Channel Stability Problems, Iao Stream, Maui, Hawaii

**U.S. Army Engineer Committee on Channel Stabilization
Report of the 64th Meeting—September 1999**

ERDC/CHL SR-00-2
CCS-00-2
June 2000

Figure 1. Cross section of armored channel adjacent to existing levee

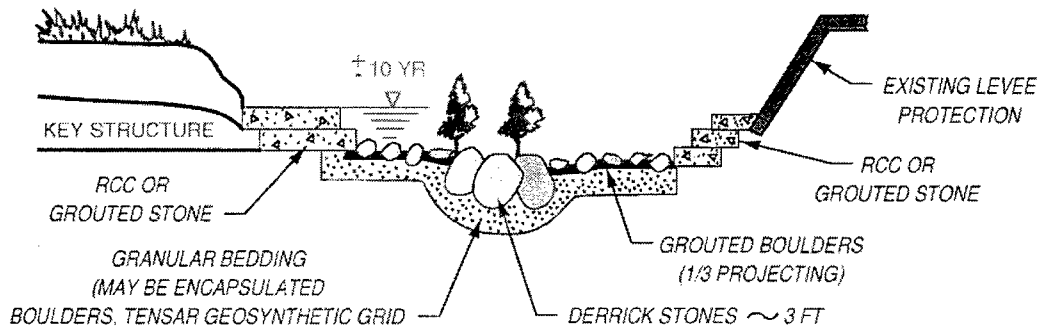
Key structures would prevent flanking at high flood flows. Cross channel grade control sills should also be included as a safety feature. Keys and grade control should be spaced between 200 to 500 ft.

Figure 3. Profile of threshold channel design with slope reduced by drop structures

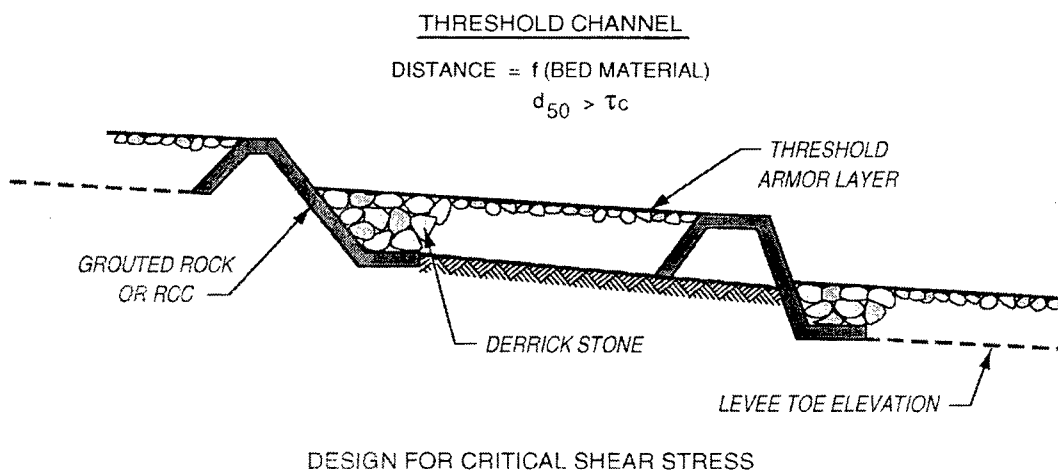
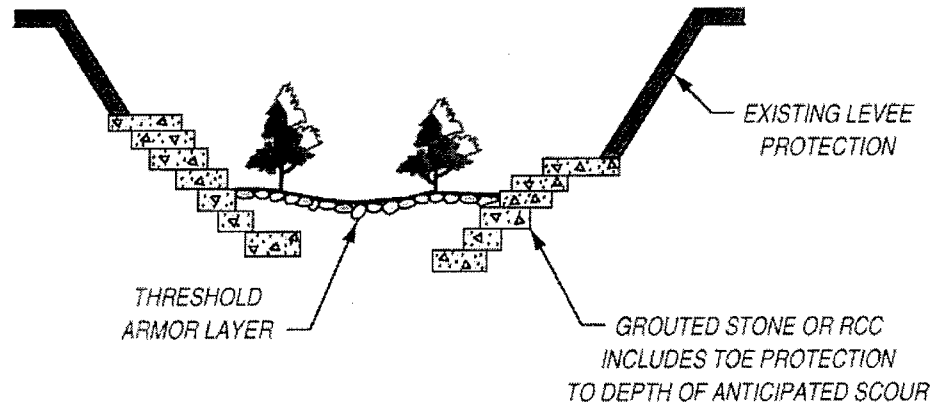
NOTE: TOE PROTECTION WITHOUT DROP STRUCTURES
REJECTED BECAUSE OF UNCERTAINTY

Figure 8. Bank protection alternative near Sta 43+00

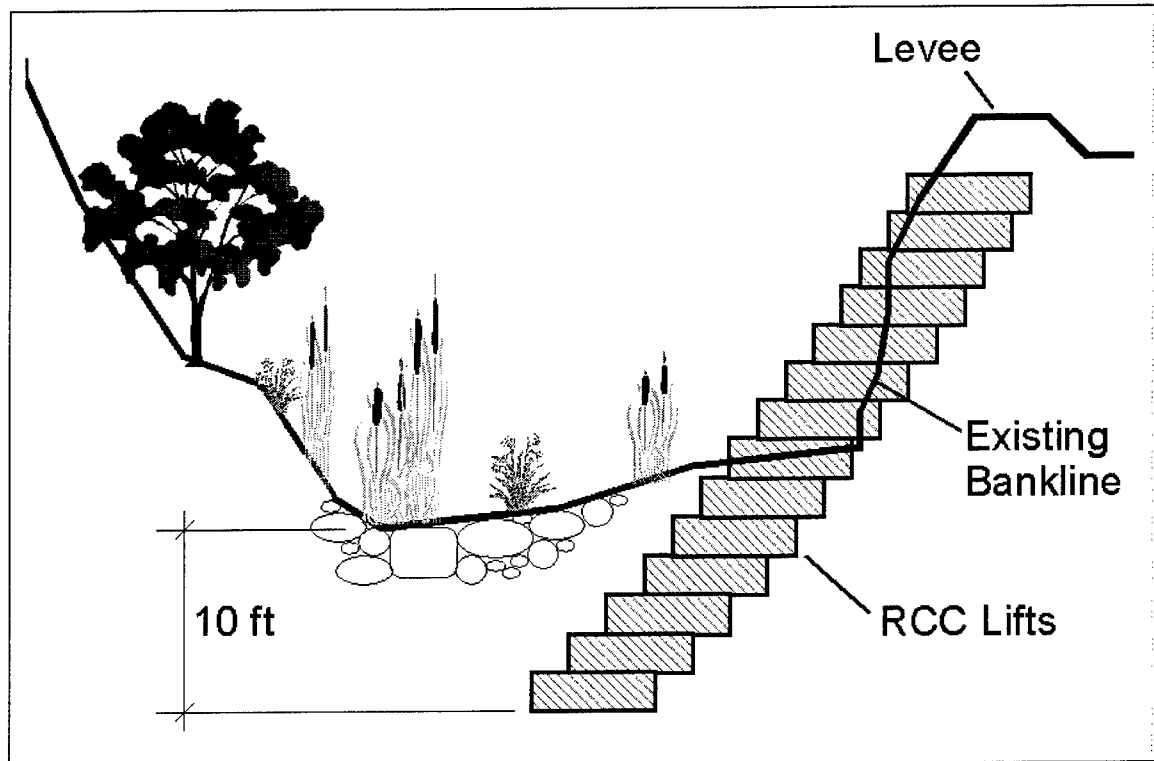
Bank protection at Sta 43+00. During the field trip, one of the more spectacular sights included the eroding bank near Sta 43+00. It appears that the sideslope of the right levee (Levee B) has eroded by as much as about 15 to 20 ft (or more) horizontally. I would recommend that POH give this reach top priority since failure of the levee is imminent. I envision that the roller-compacted concrete (RCC) sideslope discussed for the channel alternative be constructed along the right bank as soon as possible along this critical reach (Figure 7). Future construction of the channel could be designed to tie into this "early-built" section as necessary. Perhaps, the RCC sideslope could be constructed a minimum of 10 ft below the existing thalweg to prevent undermining, at least for the next few years, while at the same time providing immediate bank protection along this reach. I recommend EM 1110-2-2006 "Roller-compacted concrete" (1992) as a reference for RCC design and placement.
